# Staff Summary Report

**SUBJECT:** Hold a public meeting for a Development Plan Review for WILSON ELECTRIC, located at 600 East Gilbert Drive.

**COMMENTS:** Request for **WILSON ELECTRIC (PL080340)** (McClure Properties LLC, property owner; Sam MacLaughlin, Wilson Electric, applicant) consisting of a new one (1) story building with mezzanine at the south portion of the property, approximately 22,900 sf. in building area, on 3.37 net acres, located at 600 East Gilbert Drive in the GID, General Industrial District. The request includes the following:

**DPR08253** – Development Plan Review including site plan, building elevations, and landscape plan.

Sheet Number  
**A3**  
 Of

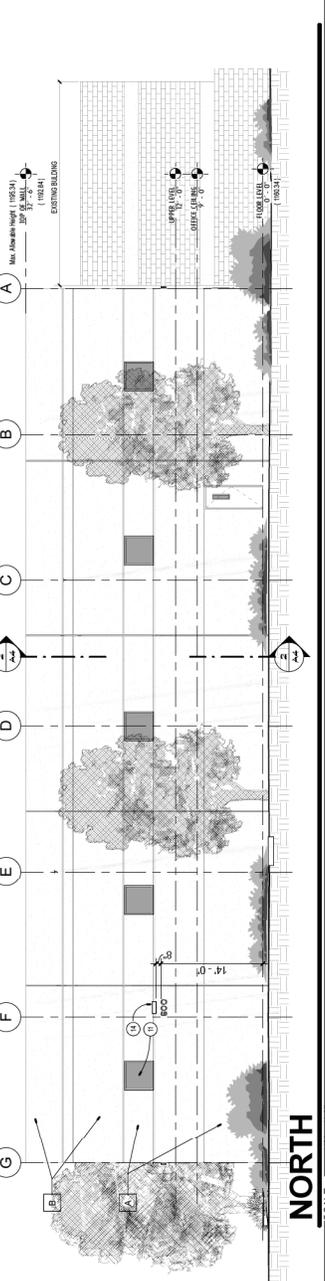
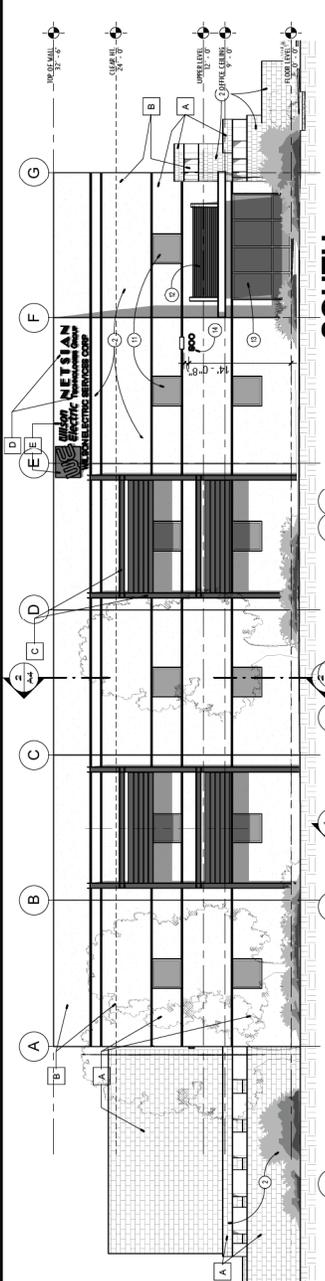
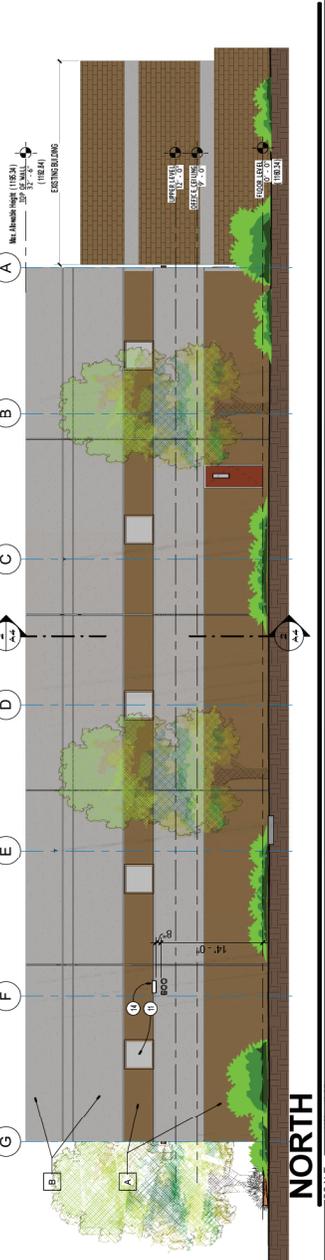
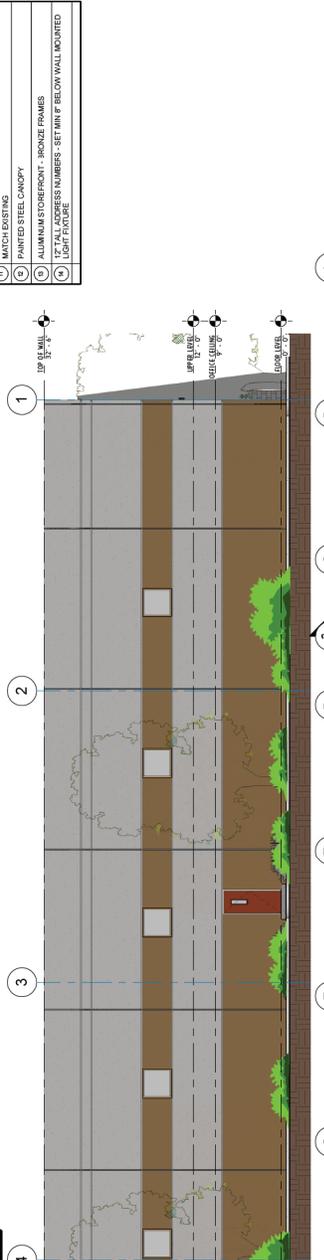
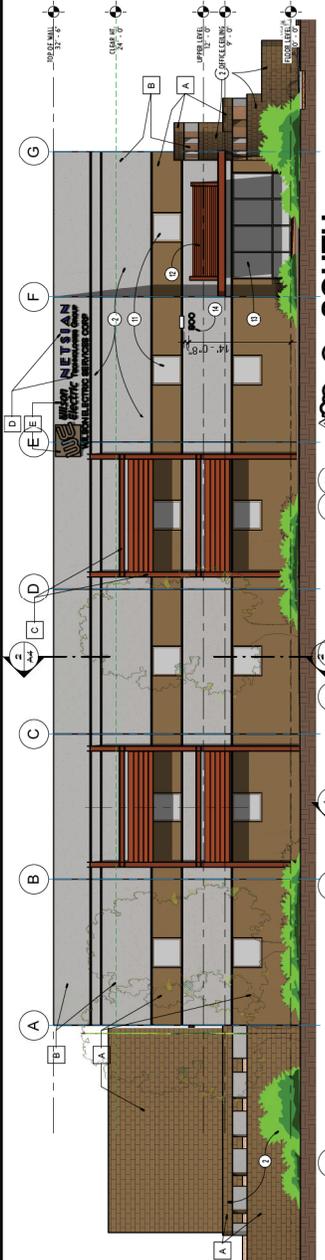
11. All new and existing roll up doors on southern building shall be painted to match the steel accent color.
12. The double scoring bands at the upper portion of the building shall be lowered so as not to conflict with the proposed sign area, pursuant to the Zoning and Development Code Part 4, Chapter 9, Signs.
